REVISIONS	
1	CONSTRUCTION
2	LIMITED CONSTRUCTION; AS NOTED
3	PRELIMINARY NOT FOR CONSTRUCTION BIDDING PURPOSES
DATE RELEASED FOR ENGR.	
THE CLEVELAND ELECTRIC ILLUMINATING COMPANY	
PERRY NUCLEAR POWER PLANT UNITS 1 & 2	
ELECTRICAL	
CABLE TRAY LAYOUT	
SECTIONS AND DETAILS	
DRAWING NO. GILBERT ASSOCIATES, INC. ENGINEERS AND CONSULTANTS	
DRAWING NO. 04 4549 D-214-652 E	
DRAWING NUMBER

TRAY LYT SECTIONS AND DETAILS

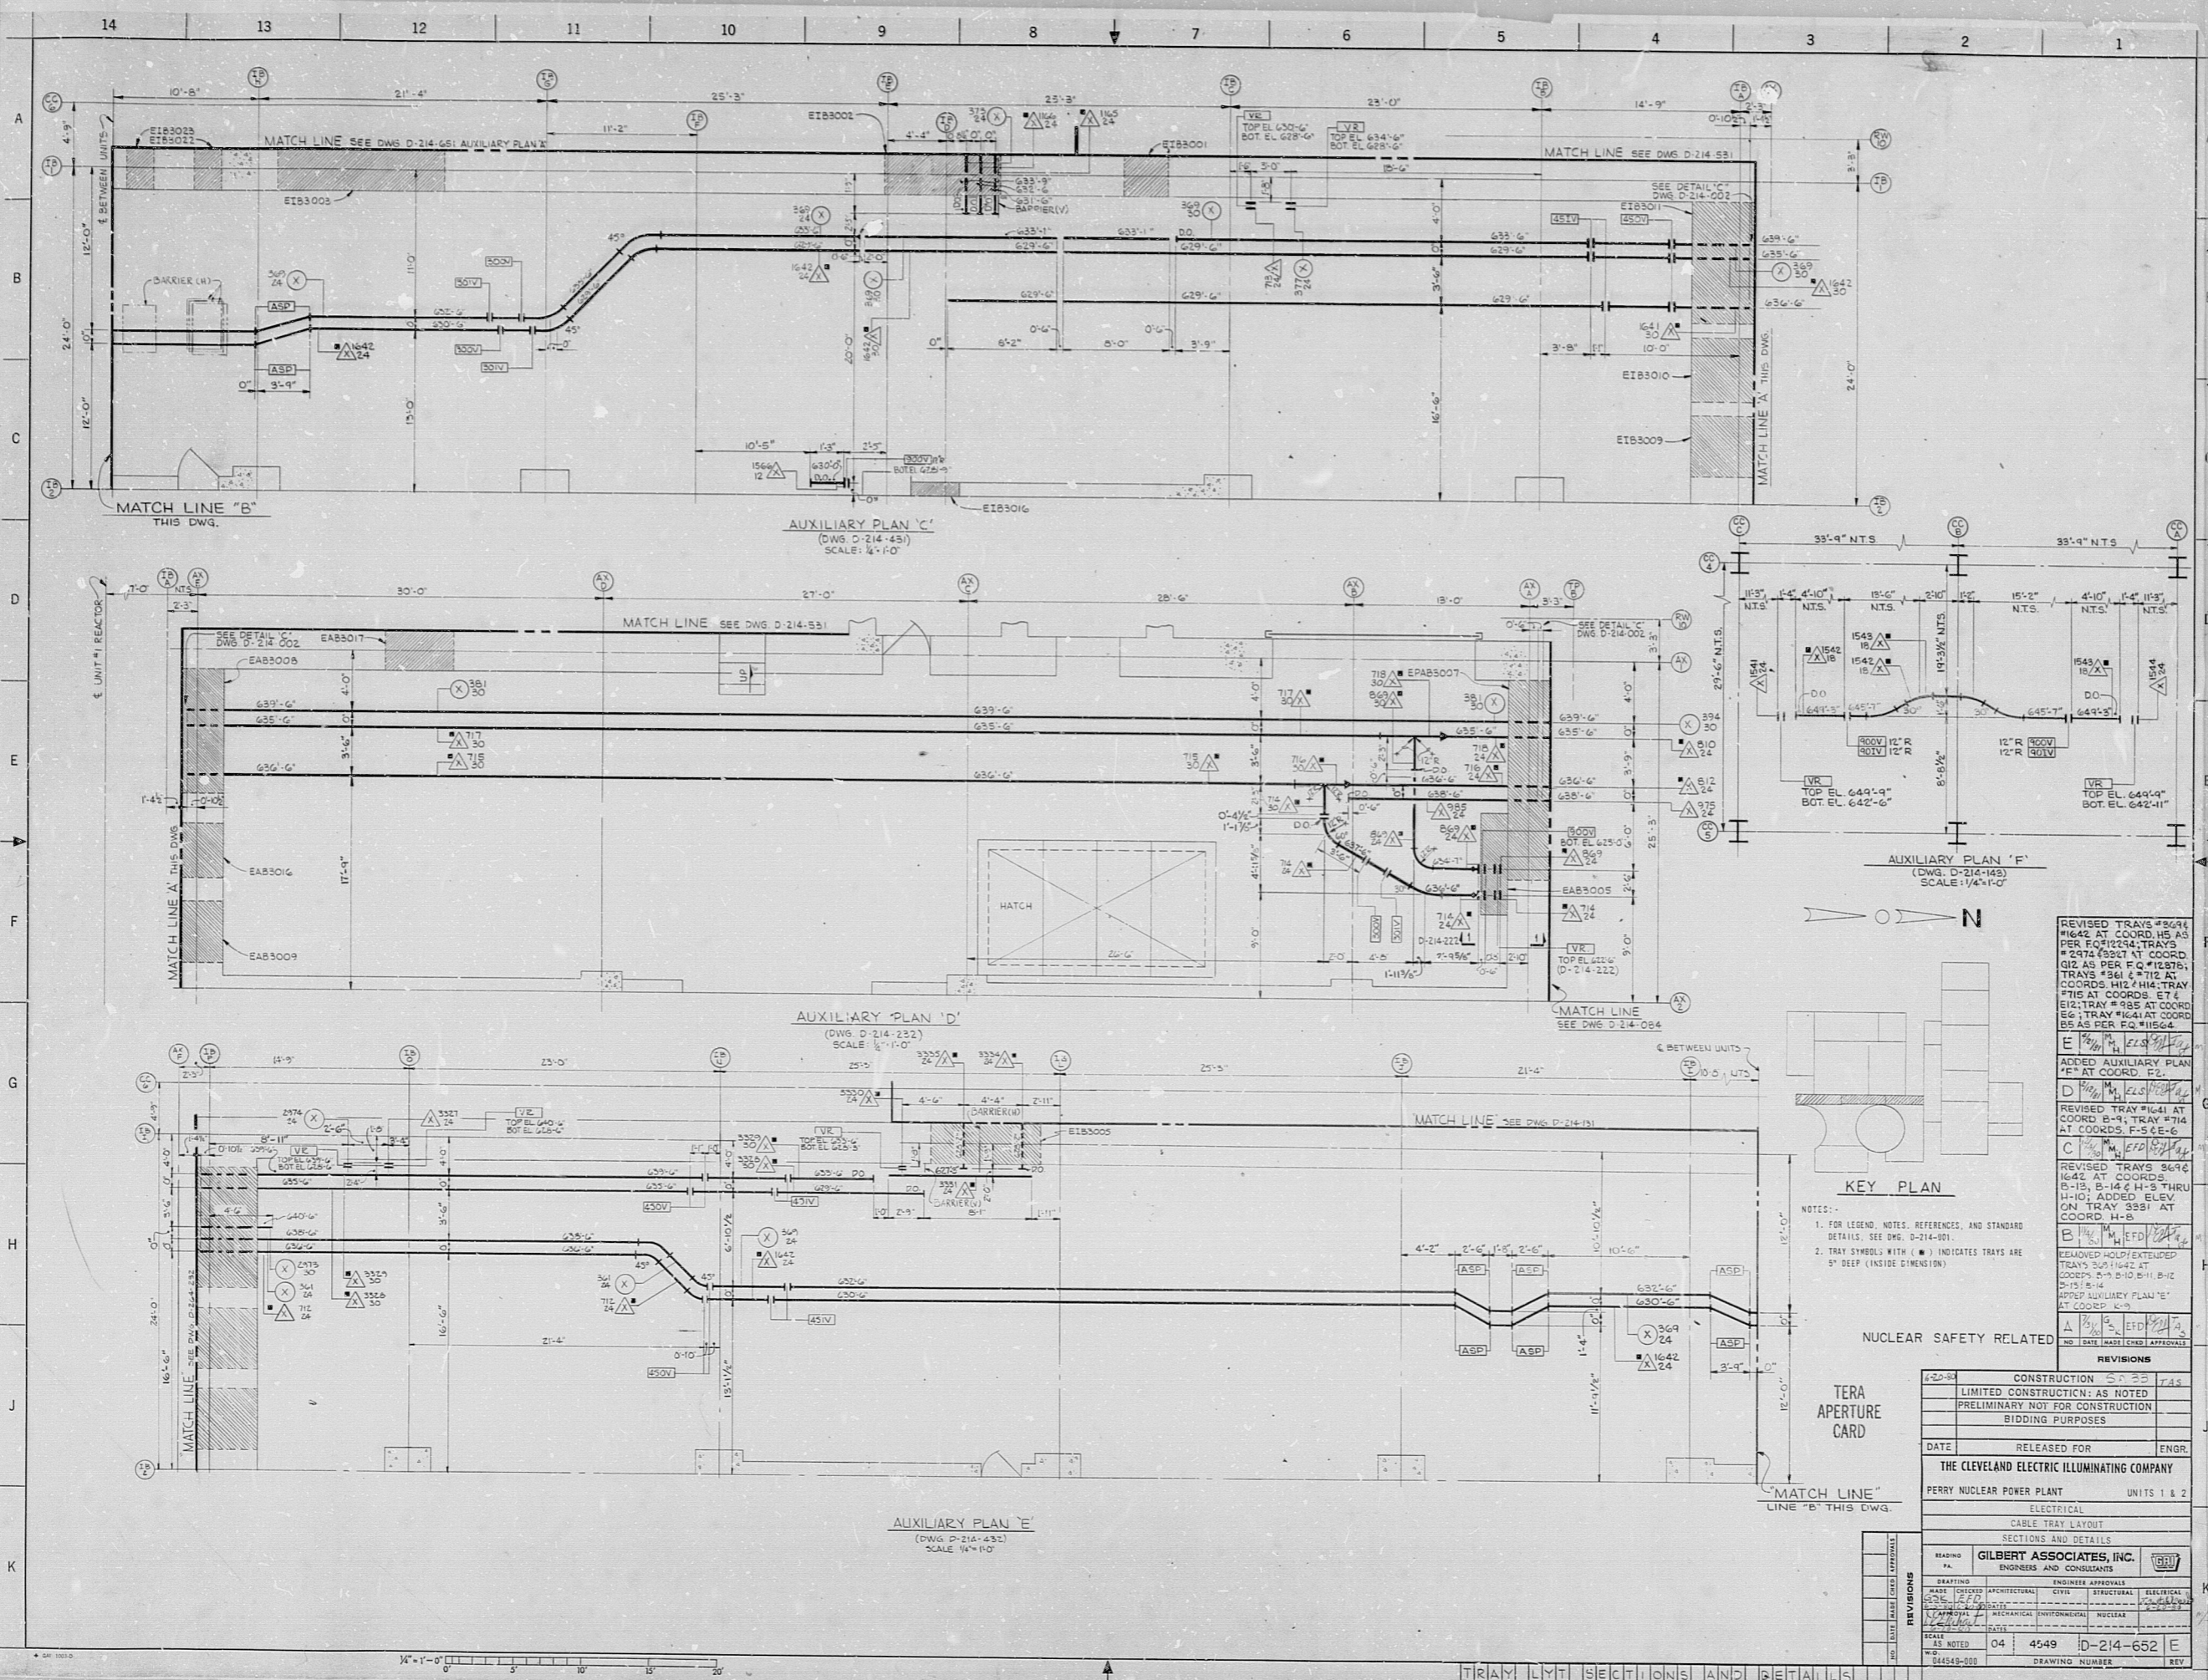
REVISED TRAYS #6416 #1642 AT COORD. H-5 AS PER FQ #1234; TRAYS #2374 #3321 AT COORD. G-12 AS PER FQ #1237; TRAYS #3616 #712 AT COORDS. H-12 / H-14 TRAY #715 AT COORDS. E-7; E-12; TRAY #885 AT COORD. E-6; TRAY #1641 AT COORD. B-5 AS PER FQ #11604

ADDED AUXILIARY PLAN #F* AT COORD. E-2.

REVISED TRAY #1641 AT COORD. B-9; TRAY #714 AT COORDS. F-4; E-6

REVISED TRAYS #6416 #1642 AT COORDS. B-13, B-14 C H-5 THRU H-10; ADDED ELEV. ON TRAY #331 AT COORD. H-8

REMOVED HOLD EXTENDED TRAYS #1642 AT COORDS. B-10, B-11, B-12, B-13, B-14

ADDED AUXILIARY PLAN #E* AT COORD. E-3
